**From:** Jeanette Coffin  
**Sent:** Friday, February 25, 2022 3:10 PM  
**To:** wpein@nc.rr.com  
**Cc:** Colleen Willger; Adam Searing; Amy Ryan; Camille Berry; Jeanne Brown; Jess Anderson; Karen Stegman; Michael Parker; Pam Hemminger; Paris Miller-Foushee; Tai Huynh; Amy Harvey; Ann Anderson; Carolyn Worsley; Laura Selmer; Loryn Clark; Mary Jane Nirdlinger; Maurice Jones; Ran Northam; Ross Tompkins; Sabrina Oliver  
**Subject:** FW: Estes Drive  
**Attachments:** Estes Drive.pdf

Petition: Do not reconstruct Estes Drive as proposed. I provide the attached paper as justification with alternatives.

# Estes Drive Proposed Bicycle Facilities

Town drawing. “Bike Lane” is a misnomer. I call it “Sidebike,” like a sidewalk for bikes. The “Sidewalk” on the right (north) side is really a Multi-use Path for bicyclists and pedestrians.

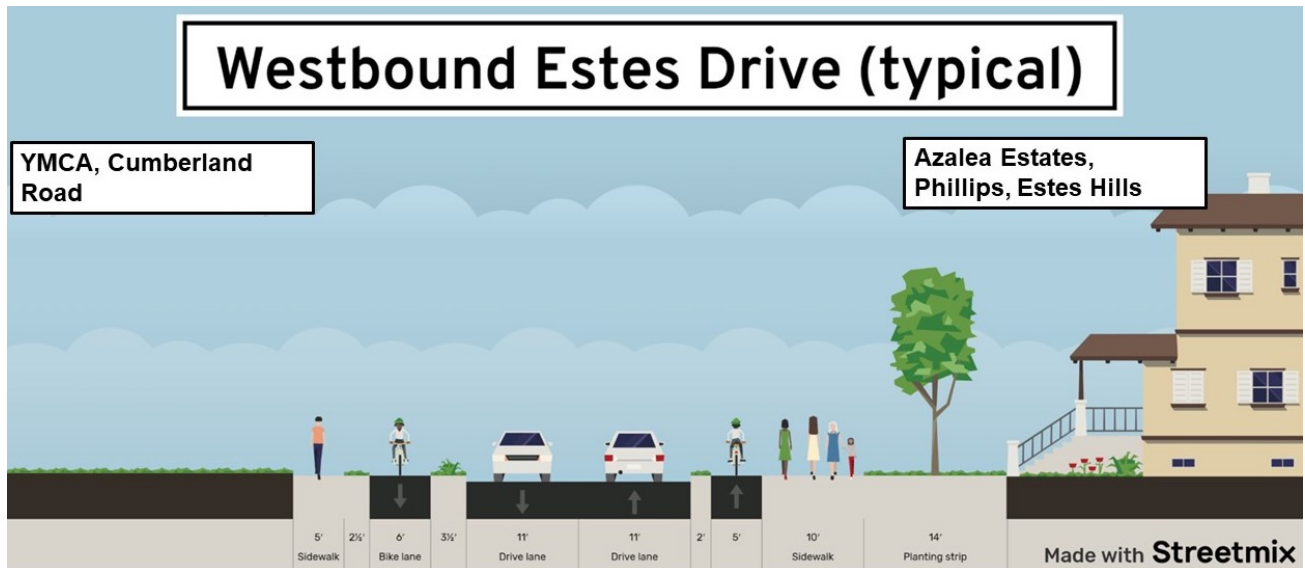
According to the project website, the proposed 6 million dollar Estes Drive redesign features two similar types of separated bicycle facility: one-way “raised bike lanes” on both sides and a 2-way multi-use paved path on the north side. Both types of facility create dangerous conflicts and remove bicyclists’ rights literally and practically by necessitating pedestrian style behavior.

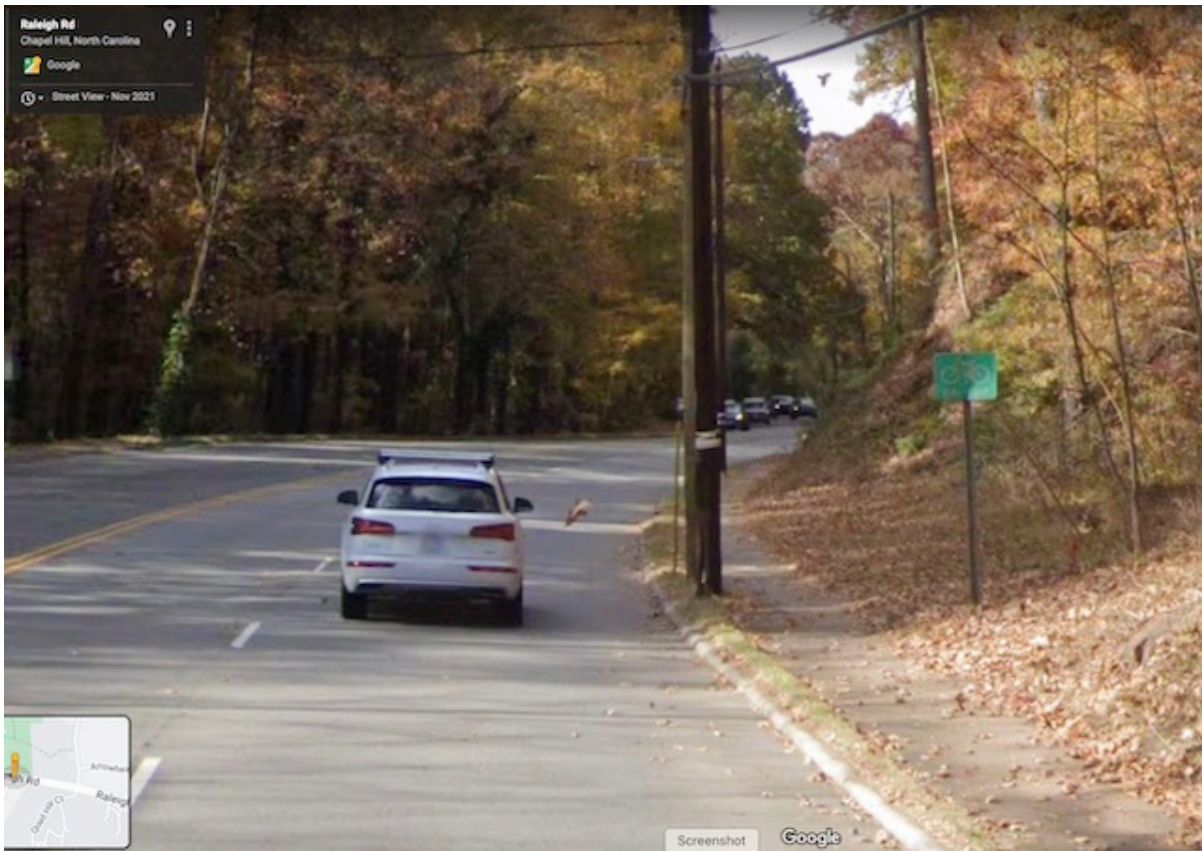
In a Zoom presentation, the Town’s Transportation Planning Manager Bergen Watterson correctly characterized the “raised bike lanes” as “Like sidewalks for bicyclists.” I will refer to them as “Sidebikes.” As with sidewalks, the Sidebikes are grade separated behind the curb and gutter and not part of the roadway, and suffer the same driveway and intersection conflicts, uneven transitions, and undulations.
